Addendum to the rehabilitation and landscape management strategy

Re: New Cobar Complex Project Response to Submissions - Rehabilitation

2.1 Resources Regulator submission request 1 – post mining land use

2.2 Resources Regulator submission request 2 – conceptual final landform design

Figure 2.1 Relationship between contact cover and soil loss (Kirby 1969)

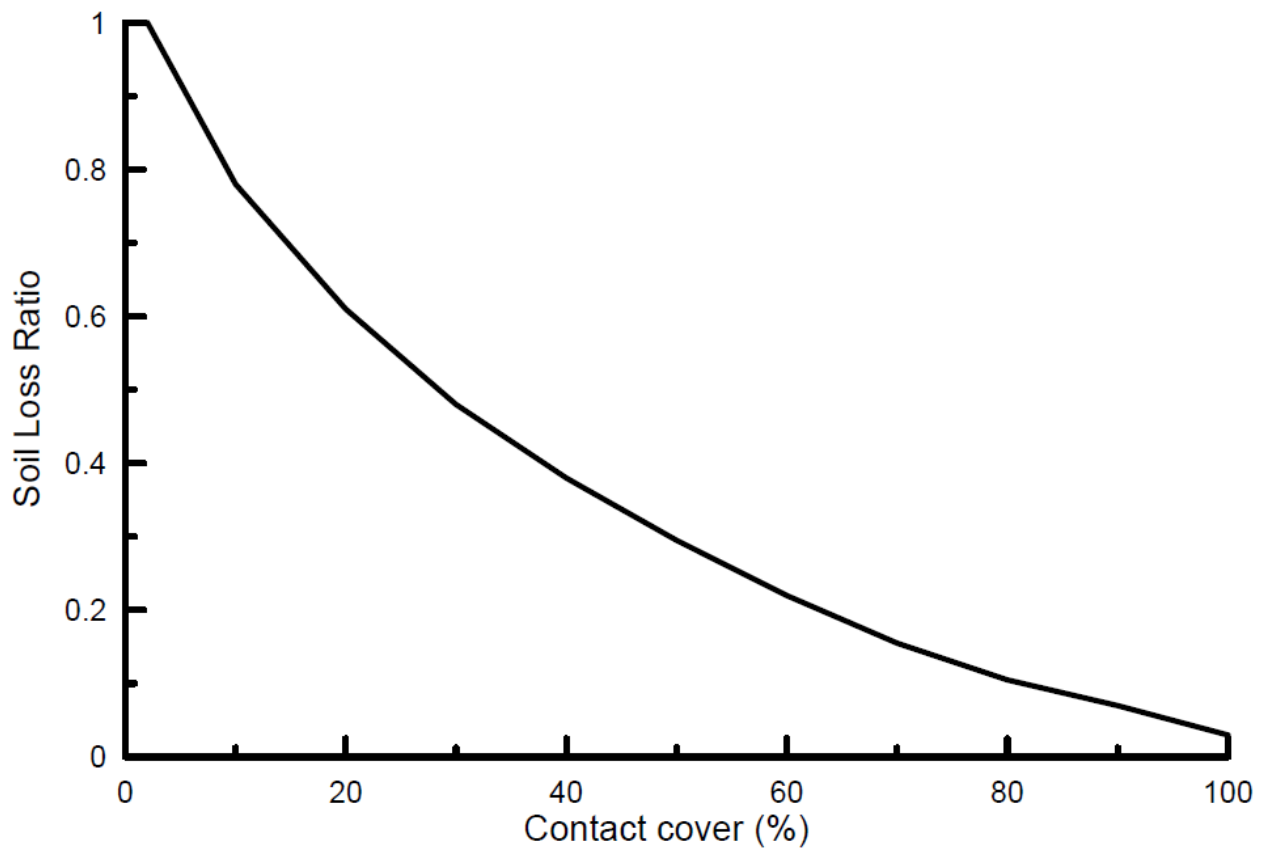
Further information is required in relation to the extent of change to the final landform of the WRE, including strategies to ensure that exposed Potentially Acid Forming material will be encapsulated to ensure that the landform is stable in the long term.

Development of a conceptual final landform plan may not be feasible at this stage given the unknowns about the quantity of material to be removed. A commitment is required that geomorphic landform design principles will be considered and implemented where practicable as part of the final landform to achieve long term stability.

It is noted that the Proponent has commitment to undertake additional waste rock and soil characterisation studies and that a Landform Evolution Model will be used to scope the degree of re-work required on both the northern and eastern batters of the existing WRE to address erosion and vegetation failure issues that have occurred.

The cover response curve developed by Kirby (1969) (Figure 2.1) shows that the impact of contact cover on erosion is not adequate until a cover level greater than approximately 30% is achieved.

This means that other forms of soil surface cover such as timber debris or rock in combination with vegetation will be required to provide adequate erosion protection on the WRE.

Rock/soil matrices have been used successfully on other mine sites in Australia with these climatic constraints, the most relevant being Cowal Gold in NSW. They consist of a ratio of approximately three parts rock to one part soil with proportions adjusted such that it is close to the optimal packing density for binary mixture (pers.comm. R Loch).

Because of its high level of erosion resistance and low rates of erosion, the rock/soil matrix layer only needs to be 300 – 500mm deep. Importantly:
